NINE MILE POINT NUCLEAR STATION, UNIT NO. 1

AMENDMENT TO FACILITY OPERATING LICENSE

Amendment No. 31  
License No. DPR-63

ATTACHMENT TO LICENSE AMENDMENT NO. 31

Figure 2.1.1. Flow Biased Scram and APRM Rod Block

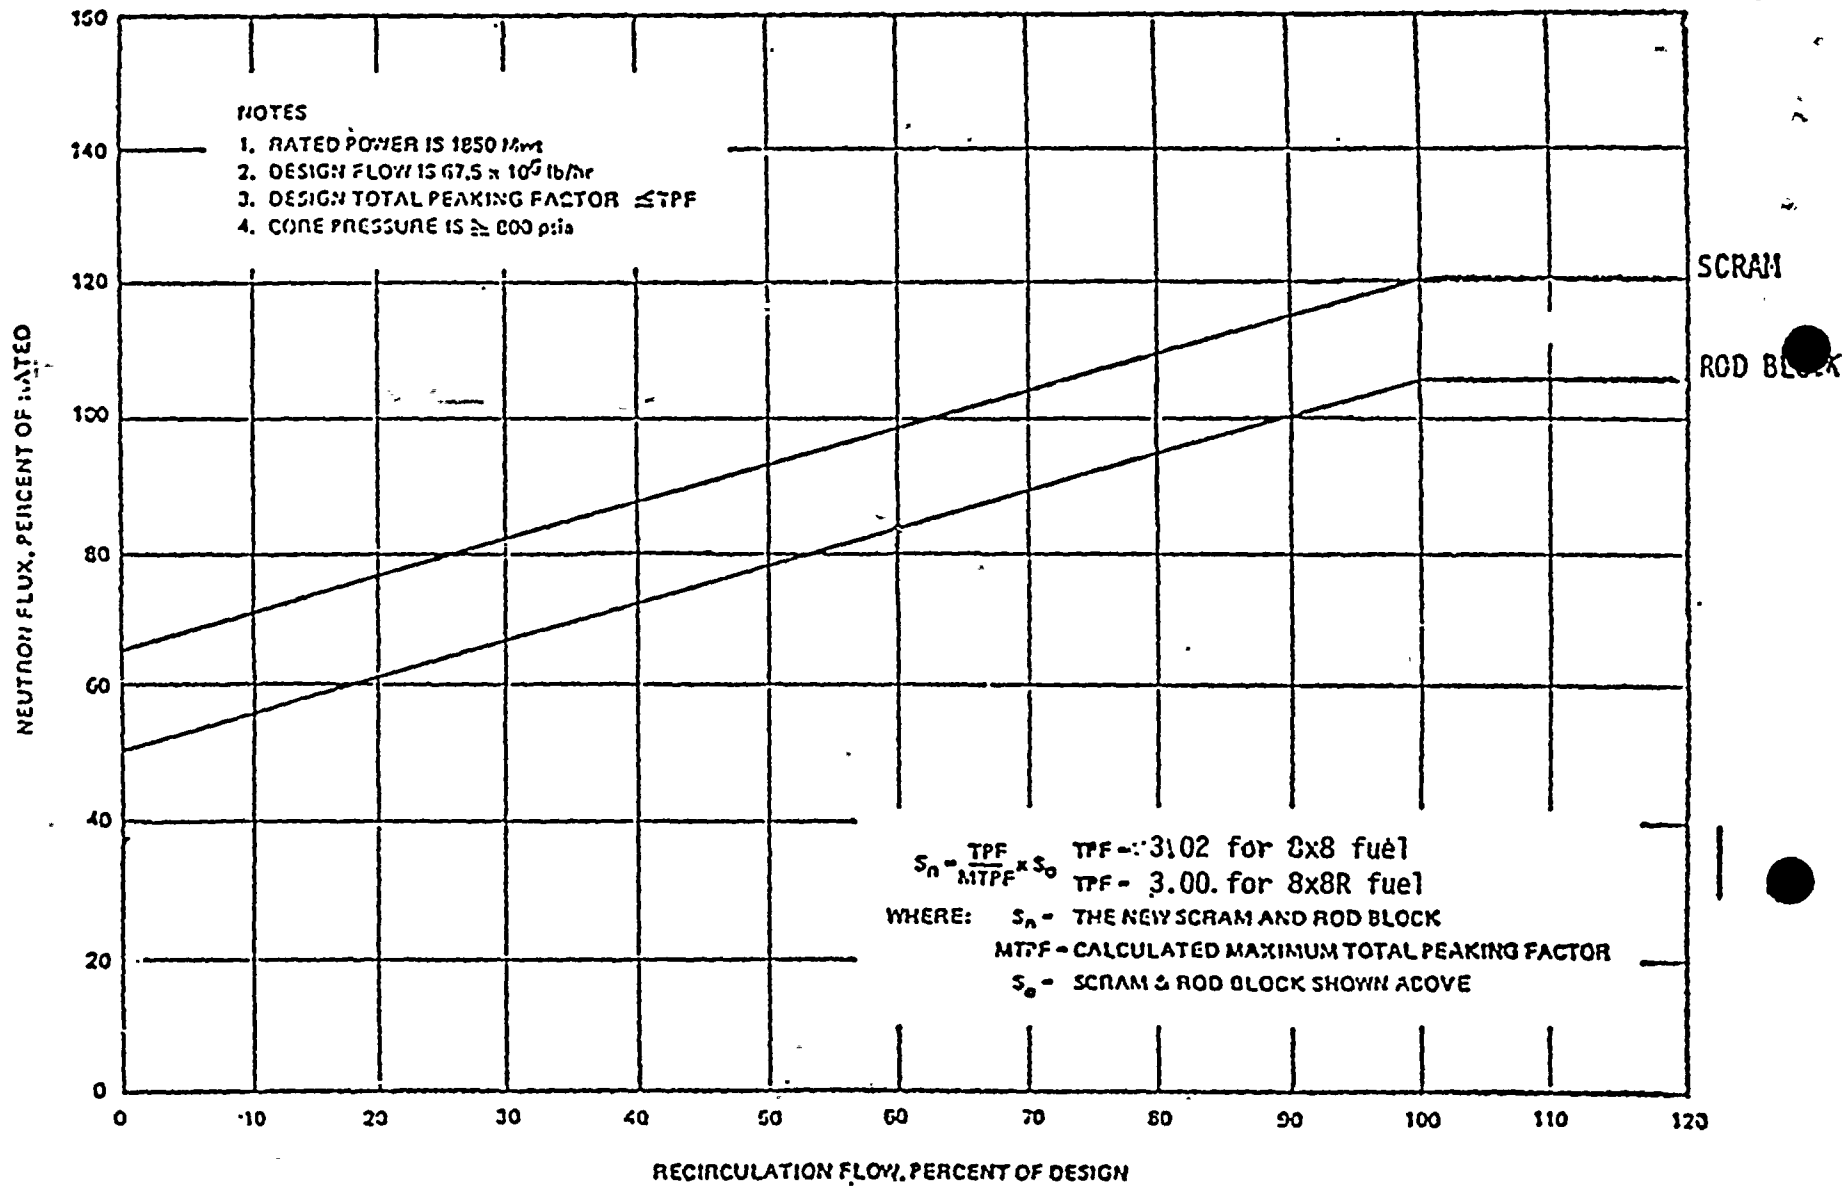
- a. The flow biased APRM scram trip settings shall be less than or equal to that shown in Figure 2.1.1.
- b. The IRM scram trip setting shall not exceed 12% of rated neutron flux.
- c. The reactor high pressure scram trip setting shall be  $\leq$  1080 psig.

In addition to the boiling transition limit ( $MCPR = 1.07$ ) operation is constrained to a maximum LHGR of 13.4 kW/ft for 8x8 fuel and 13.4 kW/ft for 8x8R fuel. At 100% power this limit is reached with a Maximum Total Peaking Factor (MTPF) of 3.02 for 8x8 fuel and 3.00 for 8x8R fuel. For the case of the MTPF exceeding these values, operation is permitted only at less than 100% of rated thermal power and only with reduced APRM scram settings as required by Specification 2.1.2.a. (In cases where for a short period the total peaking factor was above 3.02 for 8x8 fuel and 3.00 for 8x8R fuel the equation in Figure 2.1.1 will be used to adjust the flow biased scram and APRM rod block set points.

Figure 3.1.7a MAXIMUM ALLOWABLE AVERAGE PLANAR LHGR APPLICABLE TO 8DB250 and 8DB262 FUEL AS DESCRIBED IN REFERENCE 8.

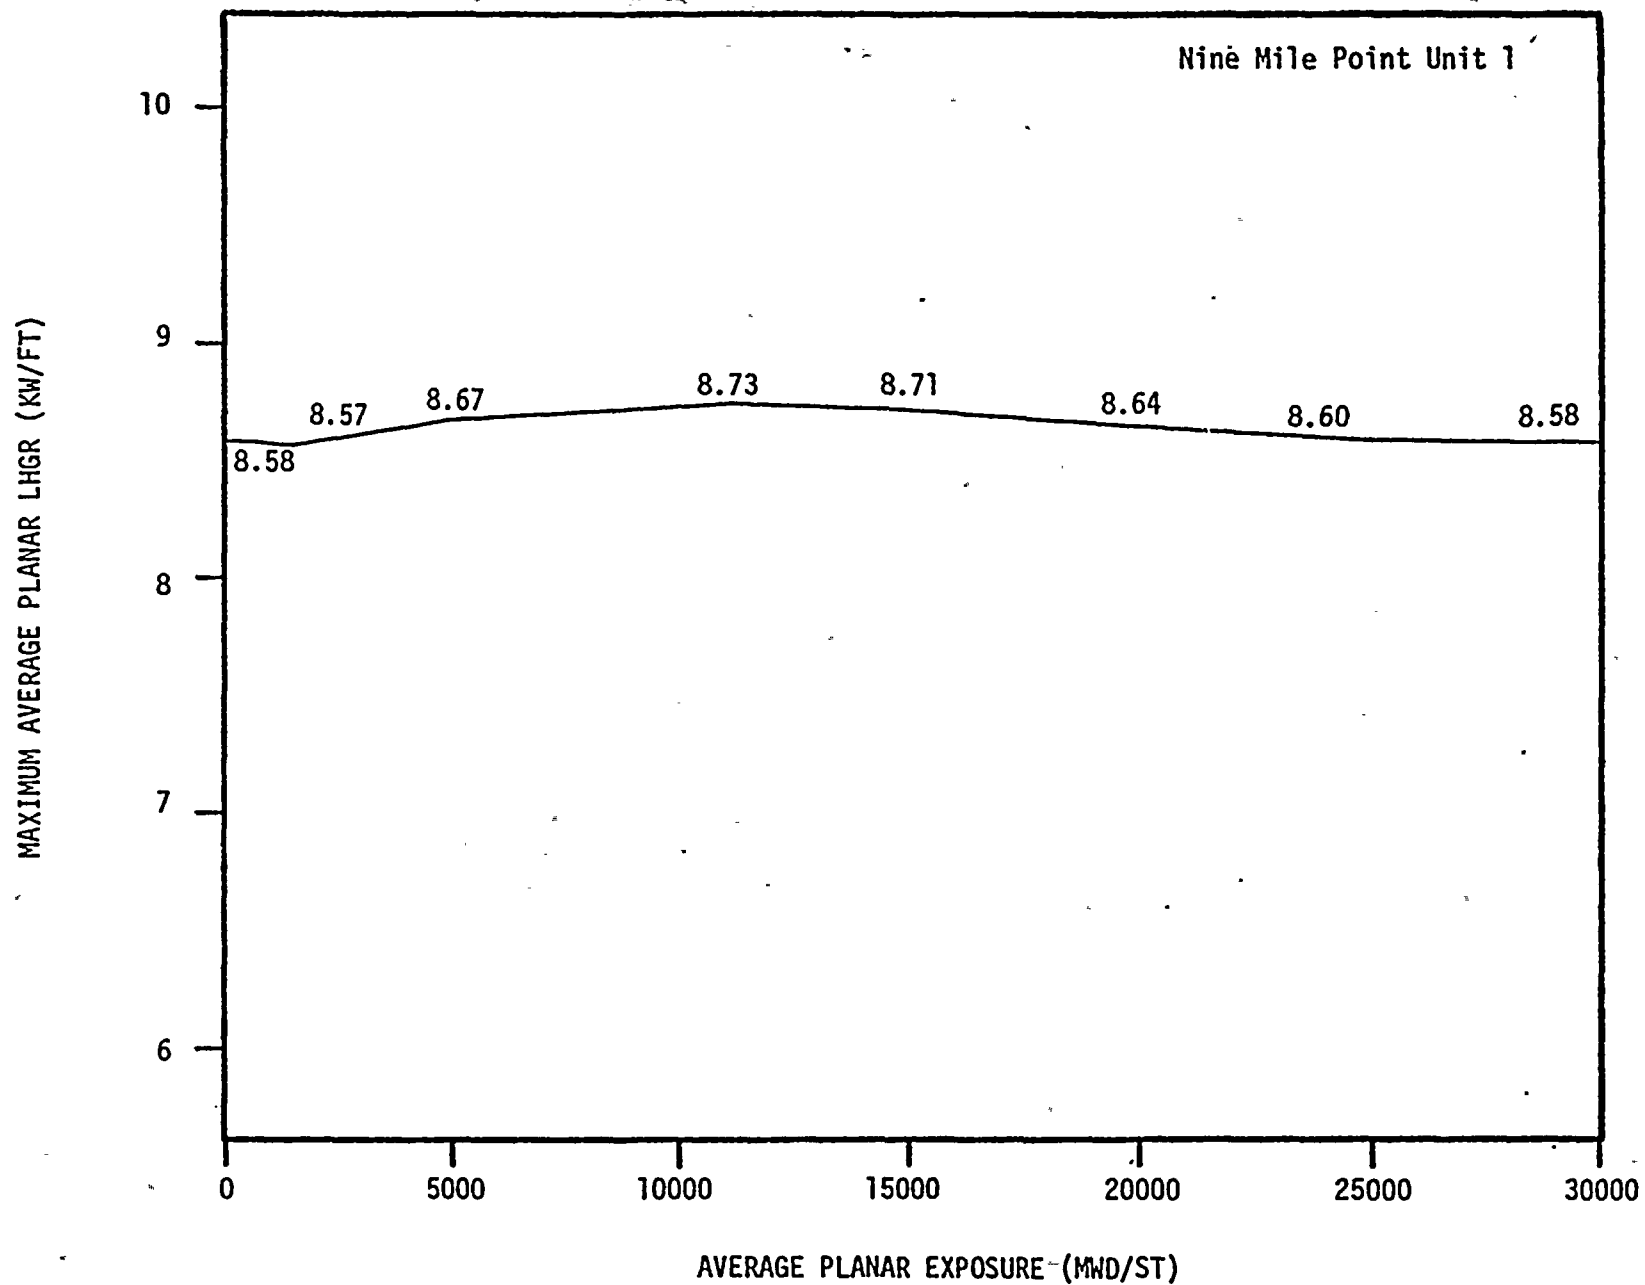
During power operation, the APLHGR for each type of fuel as a function of average planar exposure shall not exceed the limiting value shown in Figures 3.1.7a, 3.1.7b, and 3.1.7c. If at any time during power operation it is determined by normal surveillance that the limiting value for APLHGR is being exceeded at any node in the core, action shall be initiated within 15 minutes to restore operation to within the prescribed limits. If the APLHGR at all nodes in the core is not returned to within the prescribed limits within two (2) hours, reactor power reductions shall be initiated at a rate not less than 10% per hour until APLHGR at all nodes is within the prescribed limits.

During power operation with one recirculation line isolated, the APLHGR for each fuel type as a function of average planar exposure shall not exceed 98% of limiting value shown in Figures 3.1.7a, 3.1.7b, and 3.1.7c.
